Model: Katana-C2 EFI v1.1(EB-1357)	Date: 31-Jan-11	No.: RD473001a
------------------------------------	-----------------	----------------

Model: Bellini C-4 EFI (EB-1357)		Date: 03-Feb-11	No. RD473003
Subject: Parts Catalog Correction		Prepared by: S.Ishibashi	
From: PP Service Planning Department 1G			
Classification:	<input type="checkbox"/> Troubleshooting	<input checked="" type="checkbox"/> Part information	<input type="checkbox"/> Action required
	<input type="checkbox"/> Mechanical	<input type="checkbox"/> Electrical	<input checked="" type="checkbox"/> Service manual revision
	<input type="checkbox"/> Paper path	<input type="checkbox"/> Transmit/receive	<input type="checkbox"/> Retrofit information
	<input type="checkbox"/> Product Safety	<input type="checkbox"/> Other ( )	<input type="checkbox"/> Tier2

Model: <b>Katana-C2 EFI v1.1 (EB-1357)</b>		Date: 25-Nov-10	No.: RD473004
Subject: Release of Color Controller EB-1357 Ver.1.1 (with system software Ver.1.1)		Prepared by: S.Ishibashi	
From: PPBG Service Planning Dept.			
Classification:	<input type="checkbox"/> Troubleshooting	<input type="checkbox"/> Part information	<input type="checkbox"/> Action required
	<input type="c

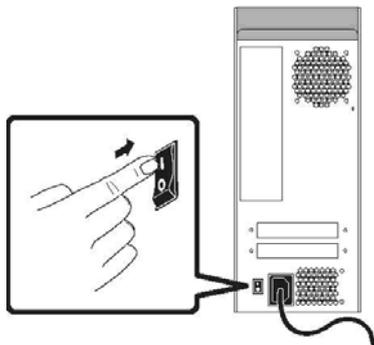
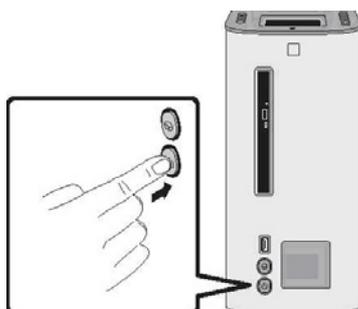
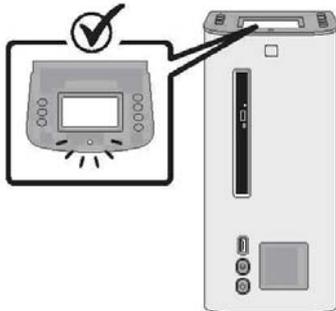
**Change:** Part number and description of the PSU

**Reason:** The new PSU has no functional change on the server but meets the requirements of the EUP directive for Europe.

The switch on the PSU does not add any functionality. The only difference will be that the switch must be "ON" for the server to function.

**Note:** With the new PSU, the startup procedure of the EB-1357 has changed as follows.

**TO START THE EB-1357**

1. Make sure that the power cable is attached and that the power switch (if present) is in the ON position.

2. Press the power button on the front panel.

3. Check the Activity light on the Control Panel.
